Office Action Summary

10/790,318

OYASKI, MICHAEL F.

FIGURE 9

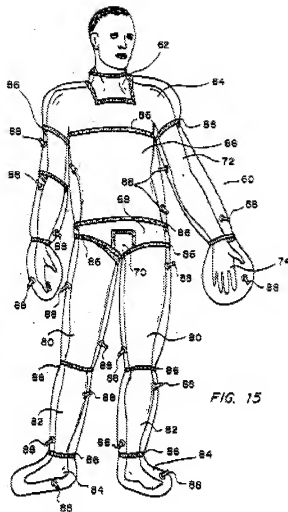
and said damaged body tissue, a first one of said fluid transfer means that is capable of allowing communication of said gaseous fluid and a second one of said fluid transfer means that is capable of allowing communication of said liquid fluid to such space disposed between said inner surface of said bodysuit and such damaged body tissue thereby enabling such damaged body tissue to be effectively treated and healed in controlled environmental conditions without requiring removal of said bodysuit member and a third one of said fluid transfer means that is capable of removing each of said gaseous and liquid fluids from said bodysuit (60)(see figs. 9 & 15, below)(col. 20, lines 62-65; col. 21; lines 51-68)(abstract).

Eriksson discloses a bodysuit with separate chambers each having at least two ports (88). One of the chambers could be filled with a gas through one of its ports, another chamber could be filled with a liquid through one of its ports and a third chamber could be filled with a liquid-gas mixture that could be emptied from one of that chamber's ports (see fig. 15).

FIG 16

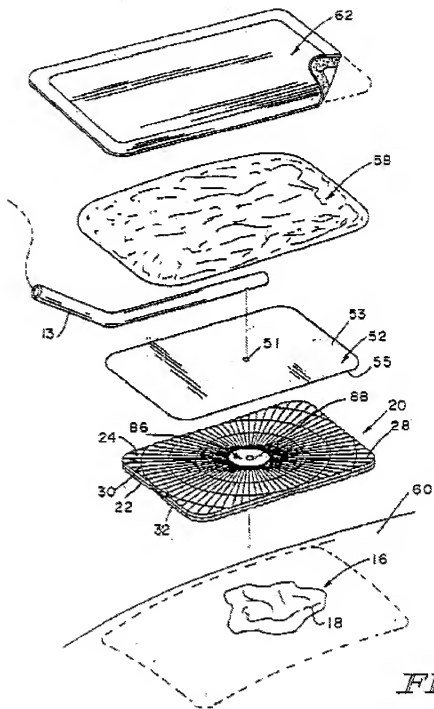
Lockwood teaches a vacuum bandage that includes a wound-contacting layer (20) with a texture (28) which channels fluids (see fig. 16, below).

At the time of the invention, it would have been obvious to one of ordinary skill in the art to add the textured channels of Lockwood to the system of Eriksson in order to provide fluid flow channels even in portions of the system that are compressed by a wearer's bodyweight, so fluid can circulate.

Further regarding claim 14, Lockwood teaches a texture (28) that permits or at least does not preclude alternating circulation of gas and liquid.
